Report on
Groundwater and Surface Water Contamination
at the Flambeau Mine

David M Chambers, Ph.D.
Kendra Zamzow, Ph.D.

Center for Science in Public Participation

June 5, 2009

Figure A: Plan View Groundwater Flow

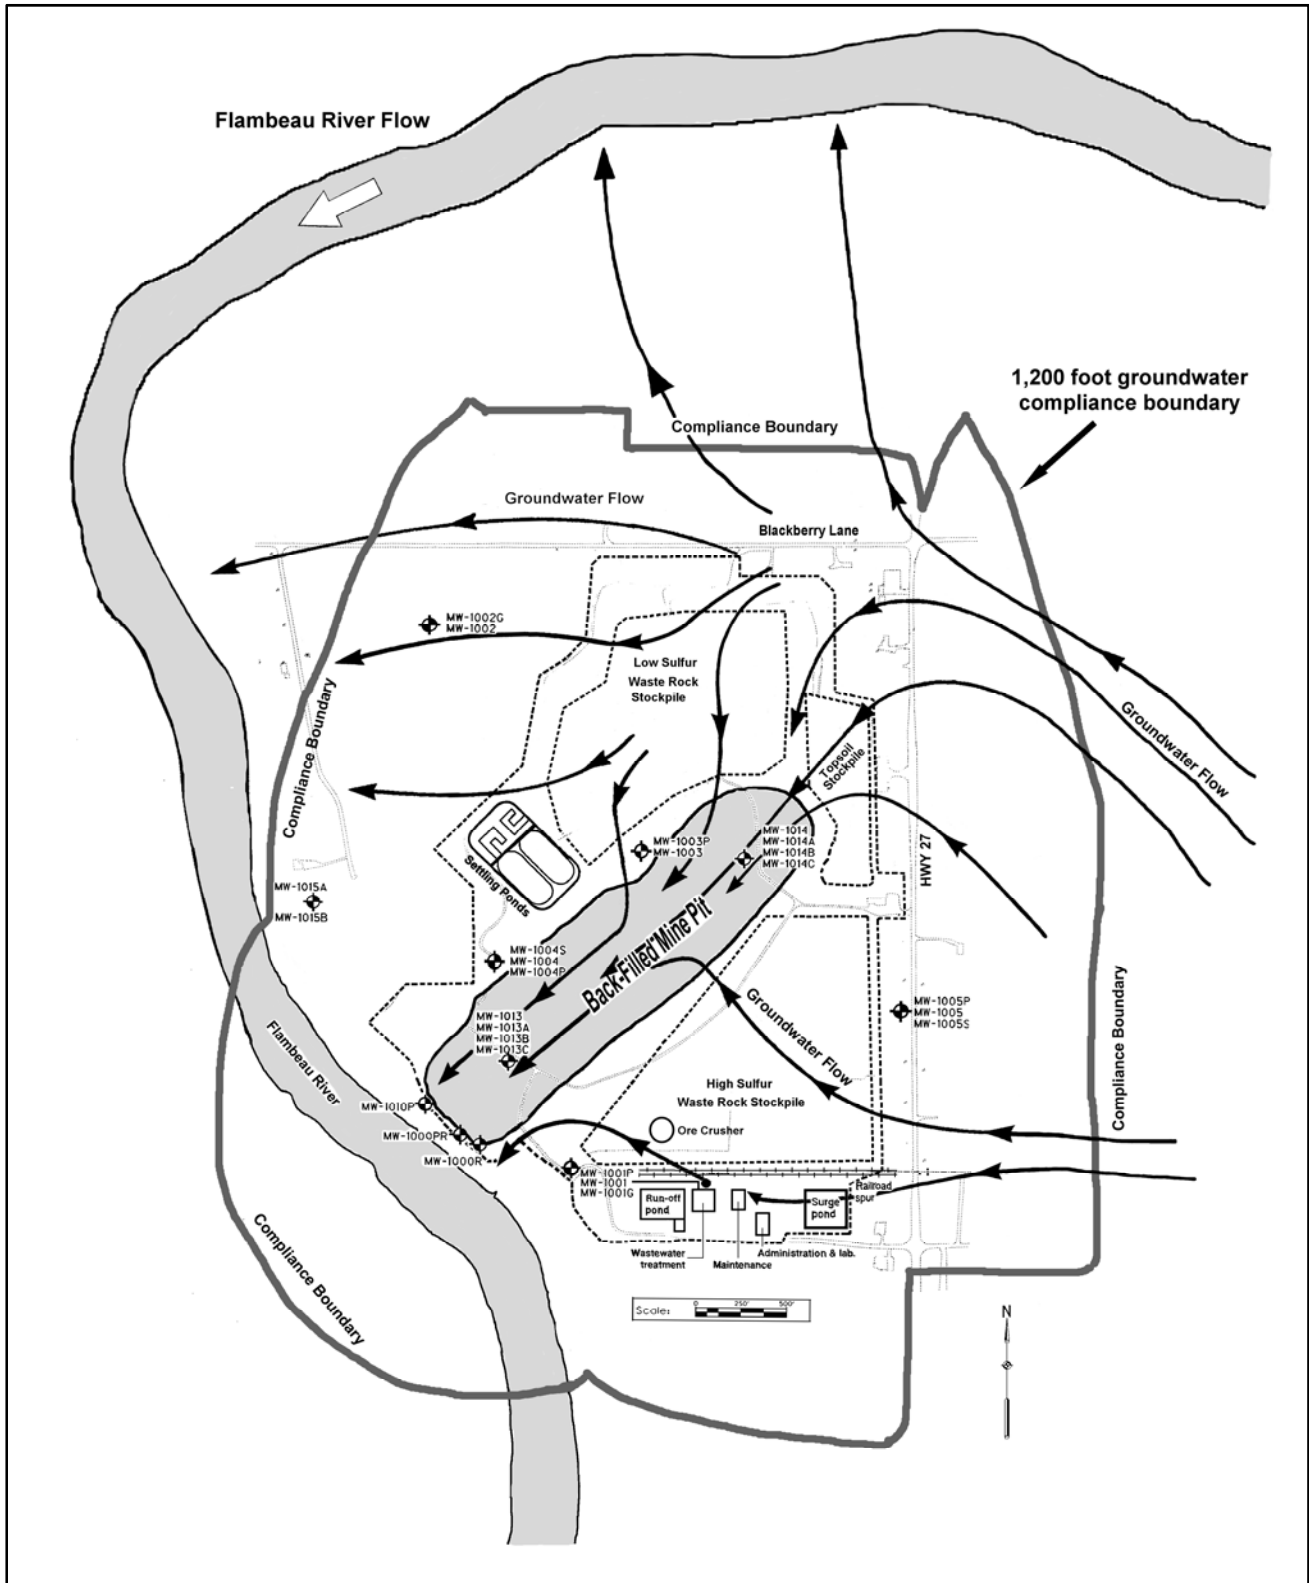
It is possible that pit water could be moving around the ends of the slurry wall. Inspection of the projected groundwater flow directions in Figure A and the groundwater potentiometric surface lines in Figure B both support this hypothesis. It appears that both MW-1000PR⁴² and MW-1010P are screened in bedrock. Since it is apparent from the MW-1000PR data that groundwater contamination is exiting the pit toward the river, two nested wells should be placed at the northwest and southeast ends of the slurry wall separating the pit from the Flambeau River. These wells would either confirm that no groundwater

Recommendation: Place nested wells at either end of the slurry wall; if MW-1000R (25' deep) is active, this could serve as one of the new monitoring wells; a deeper well should be constructed next to it. In addition, samples should be taken from MW-1001 which, although not located at the slurry wall, is nested (33', 52', 95') and located just to the southeast of the wall and would aid in determining groundwater flow direction. A monitoring well on the southern compliance boundary would ensure no contaminants are moving in that direction.

Figure E: Stream C Water Quality Data

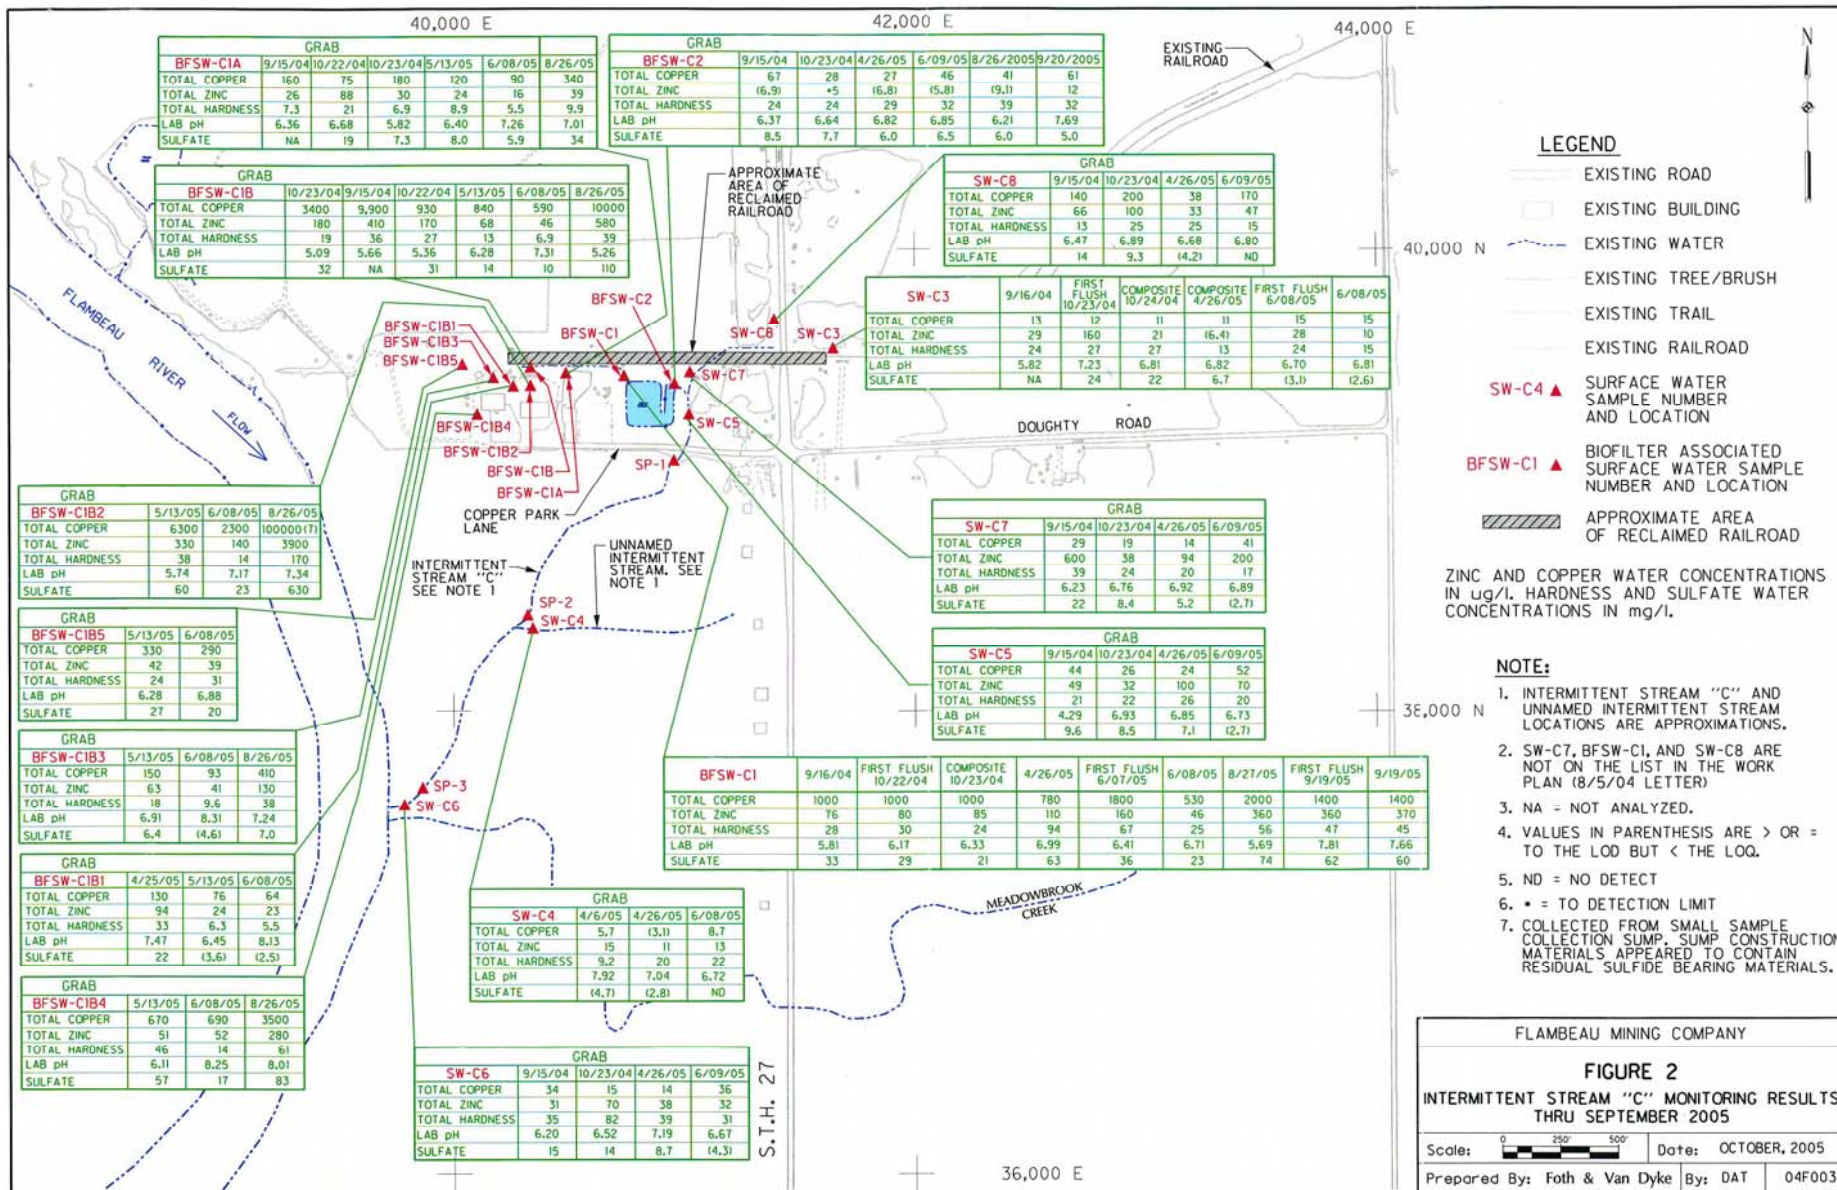
In reviewing the Foth & Van Dyke data for Stream C it is also evident that the portion of Stream C above the junction with the wetland/biofilter also carries significant copper, and possibly some zinc contamination (See Figure E, station SW-C8). In general the data also indicates the pH is normal, with some fluctuations, and the sulfate level is low. These would all suggest that metals are being sequestered in the wetland/biofilter, but that copper may be attached to suspended sediment or organic particles flowing from the wetland/biofilter. It could also be that there is just too much copper to be effectively filtered by the existing wetland. There is little data available on total suspended solids to correlate with the available water quality data.

In either case an expanded wetland/biofilter could be constructed to give more residence/treatment time to remove copper not only from the mine site drainage, but also to include water from the upper portion of Stream C above the Lot, which also shows indications of contamination.

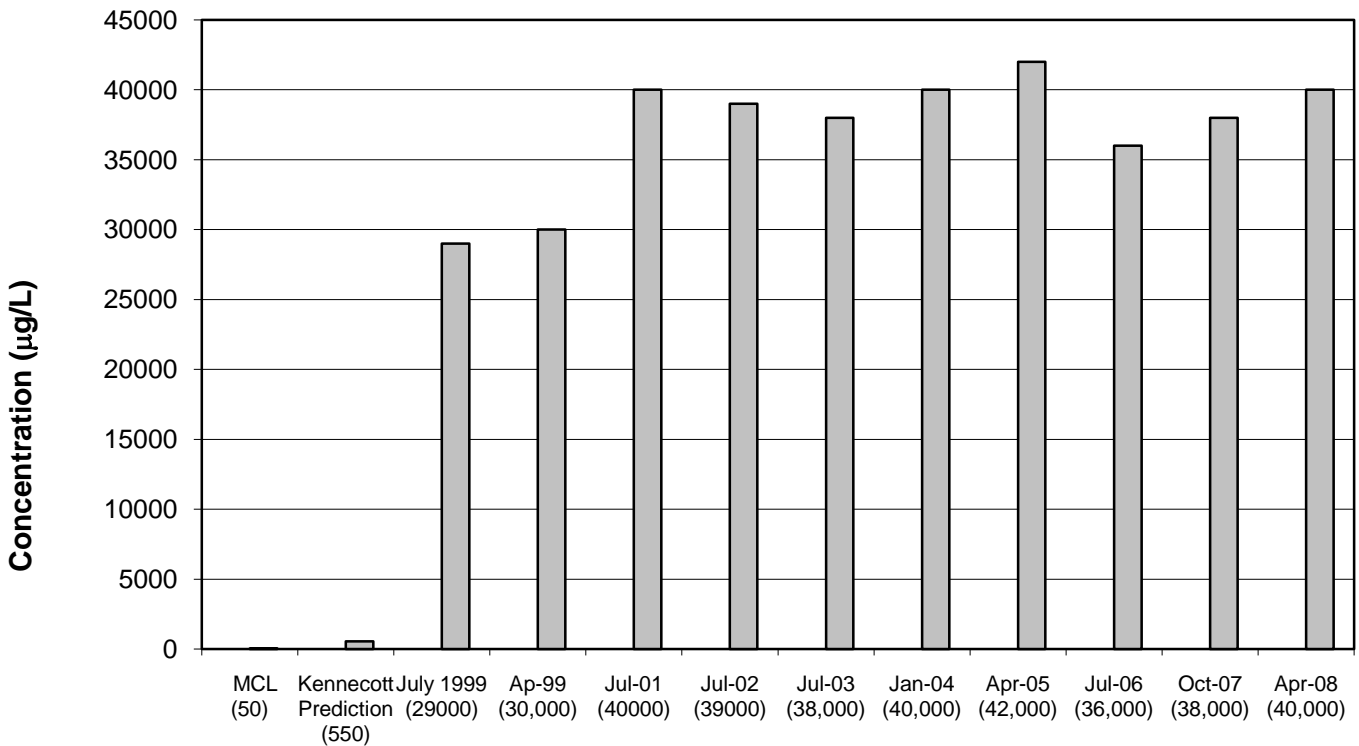
Column testing by the Flambeau Mining Company in 1997 was not able to produce the manganese concentrations predicted, but it was thought that “with an extended time manganese levels would decrease to those predicted in Table 4-23”¹⁹; i.e. 2 mg/L (2,000 µg/L) at 1% carbon dioxide.²⁰ However, ten years after backfilling, manganese concentrations in pit pore water remain underestimated by more than an order of magnitude in four of the eight pit monitoring wells (MW-1013, 1013B, 1013C, and 1014B), and fluctuate strongly in three of the remaining four (MW-1013A, 1014, 1014A) (Table 4 and Figure G).

Recommendation: Monitoring should be continued in the pit until redox stabilizes.
